SWCPP Ref. No.:	PPSSWC-124
DA No.:	DA20/0858
PROPOSED DEVELOPMENT:	Construction of a part nine storey and part five storey mixed use building comprising a public car park with 686 spaces, four storeys of office premises with a ground floor lobby and associated car parking, a multi-purpose community space on part of the ground floor, a public park on level 5, subdivision of a residual lot and associated demolition, tree removal, public domain and road works.
PROPERTY ADDRESS:	99a Henry Street, Penrith, Penrith (Soper Place Carpark)
PROPERTY DESCRIPTION:	Lot 1 Deposited Plan (DP) 1265105 Part of Lot 11 DP854412 Soper Place, public road
ZONING:	B3 Commercial Core
CLASS OF BUILDING:	Class 5 and 9
ASSESSING OFFICER:	Stephen Kerr, Consultant Planner, Gyde Consulting
APPLICANT:	Think Planners
DATE RECEIVED:	21 December 2020
REPORT BY:	Stephen Kerr, Consultant Planner, Gyde Consulting
RECOMMENDATIONS:	<p>Deferral, pending:</p> <ul style="list-style-type: none"> (a) Provision of owner's consent in respect of Lot 1 DP1265105 (the Penrith Community Health Centre); (b) Additional contamination testing as noted in the report and the provision of a Remedial Action Plan if necessary to make the l

Figure 33: Extract drawing DA03 (Rev C) showing demolition in red dash (Source: DBJ)

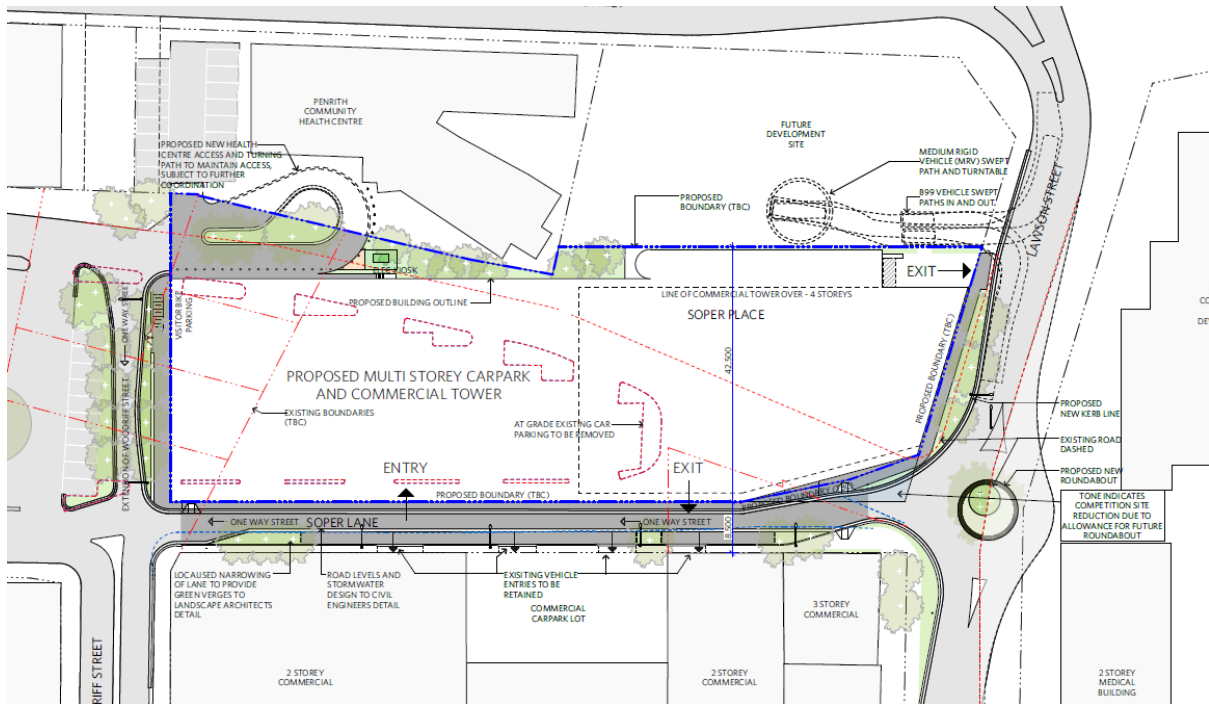
It is noted that the site plan elements in Figure 33 is superseded by later drawing revisions. The above extract is provided for demolition purposes only.

The proposal seeks consent to demolish the existing site improvements. For completeness Council requested the Demolition Plan (Drawing DA03 Rev C) be updated to capture all improvements including those listed in the Waste Management Plan. The amended packaged dated 12 August 2022 did not include an updated drawing DA03 despite the RFI response table referring to drawing DA03. The demolition plan does not take into account all expected demolition works to accommodate the proposed development, including on Lot 11 DP854412 (Penrith Community Health Centre).

Figure 47: Extract of soil sample locations and exceedances for parent lot, untested area shown with a blue rectangle (Source: JBS&G DSI, Applicant Contamination Consultant)

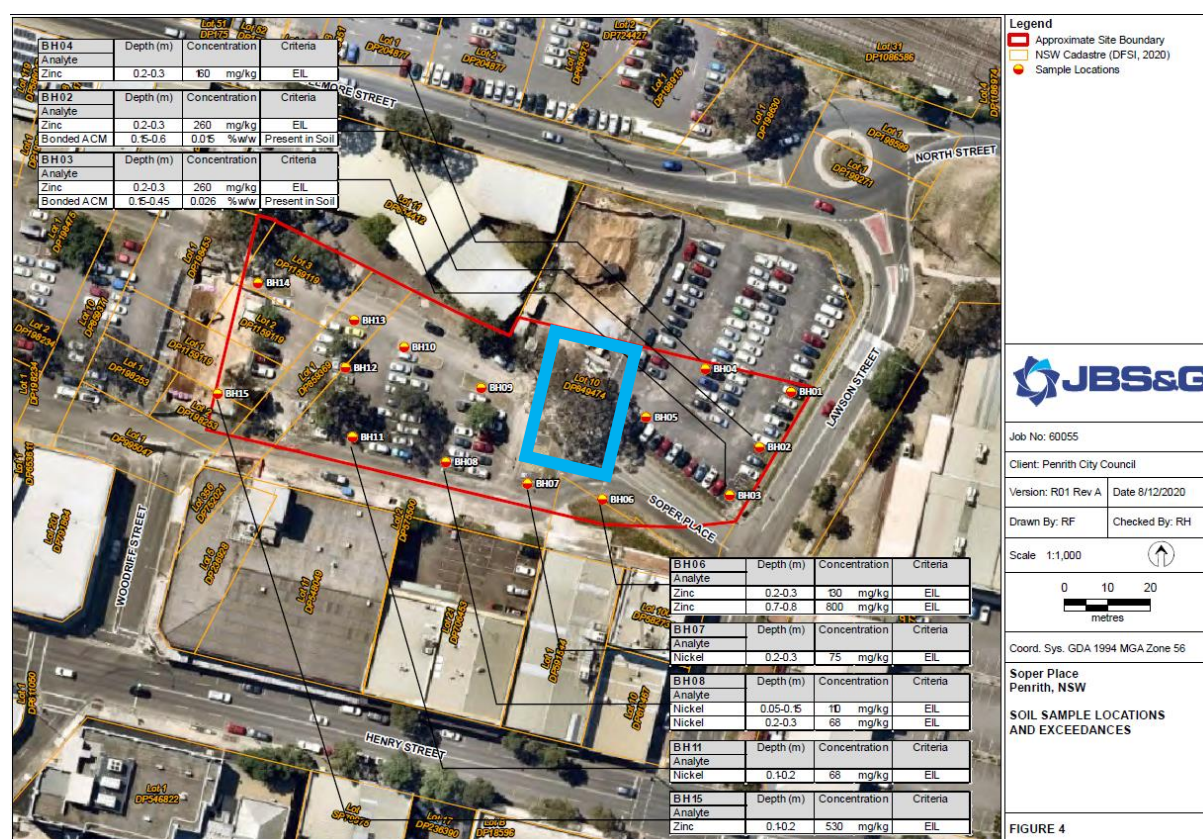
Inadequate testing has been undertaken to conclude that the parent lot is not contaminated. The following plan provides an extract of the boreholes undertaken in DSI for the parent lot.

Figure 49: Extract of Soper Place swept path, overlap circled in red (Source: Ason Group)

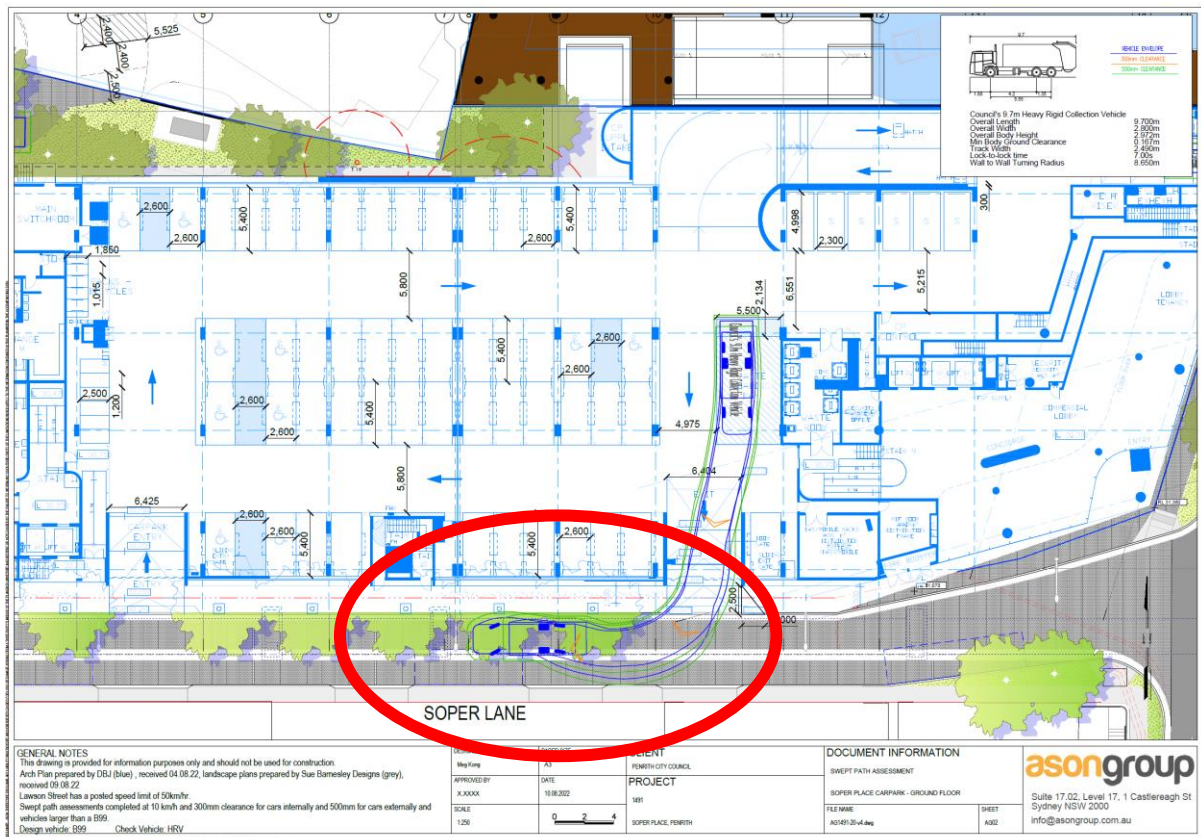
The swept path analysis provided in the Services Management Plan indicates a service vehicle exiting the proposal conflicts with loading bay 2, while a service vehicle exiting the

existing loading bay of 87- 89 Henry Street conflicts with proposed loading bay 3. Refer to the below images.

The Services Management Plan prepared by Ason Group dated 29 September 2022 identifies loading bay 2 is required for waste collection for 83- 85 Henry Street and loading bay 3 for waste collection for 87- 93 Henry Street. It is noted there is no guarantee these zones would not already be occupied.

However, Table 1 of the Services Management Plan identifies that for 83- 85 Henry Street waste bins are stored within the on-grade car park and collection occurs within the carpark. The 87- 93 Henry Street existing arrangements accommodate an 8.8 MRV and for majority of the year supports the servicing requirements of this property, noting the once-a-year semi-trailer delivery is required to Blackman Bicycles, currently this occurs kerbside. Table 1 of the Services Management Plan identifies bins for 87- 93 Henry Street are stored on the footpath and collection occurs kerbside. The swept path analysis identifies a conflict with loading bay 2 and 3. As a matter for deferral this conflict is to be resolved, including clarifying whether in fact loading bays 2 and 3 are required for waste collection for the affected properties.

- Formal owners consent for the proposed works on Lot 11 DP854412 (Penrith Community Health Centre);
- Updated Services Management Plan which:
 - Resolves the conflict with loading bays no.2 and no.3, including confirming whether they are required for waste servicing of 83- 85 Henry Street and 87- 93 Henry Street, respectively.

Figure 51: Extract of swept path (Source: Ason Group)

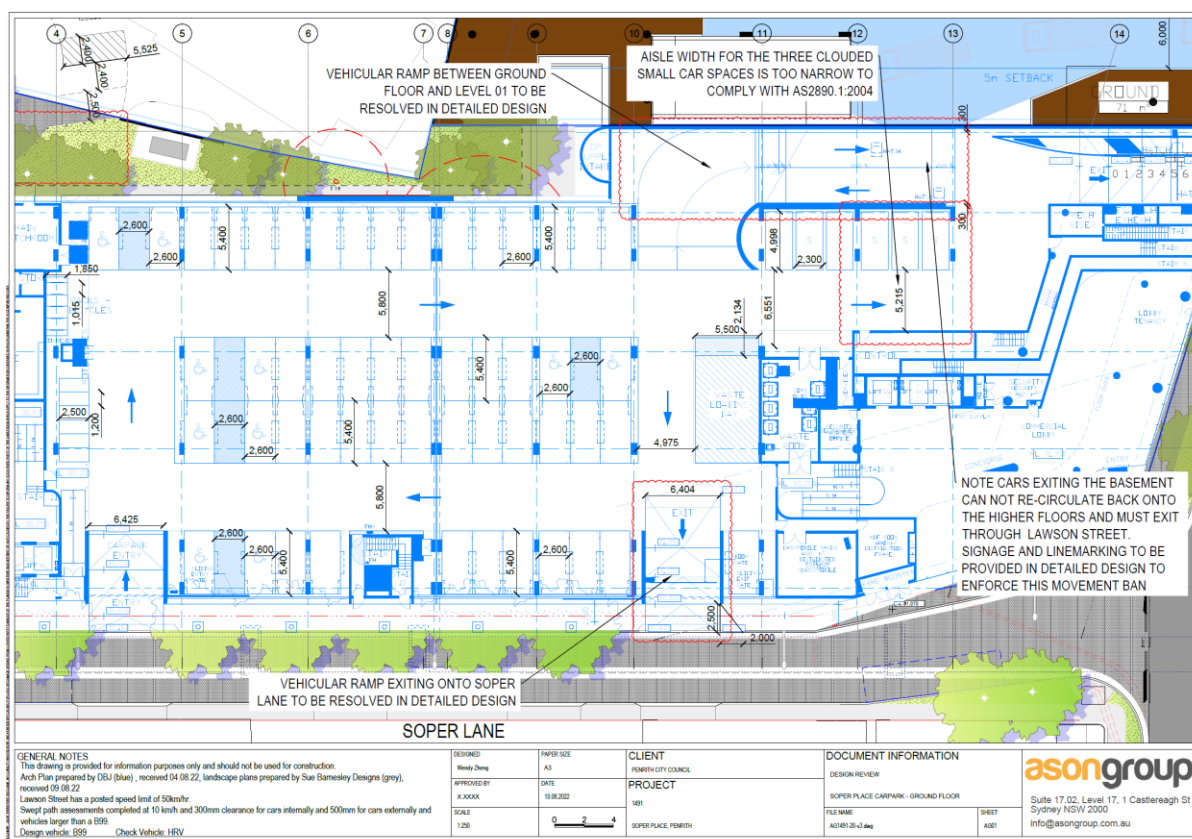
The drawings note various issues that require resolution in detailed design of the carpark including swept path drawing AG1491-20-v3 which illustrates the aisle width of 5.215 metres (shown in clouded red) is too narrow to comply with AS2980.1:2004, see below plan.

These matters can be resolved via a condition of consent.
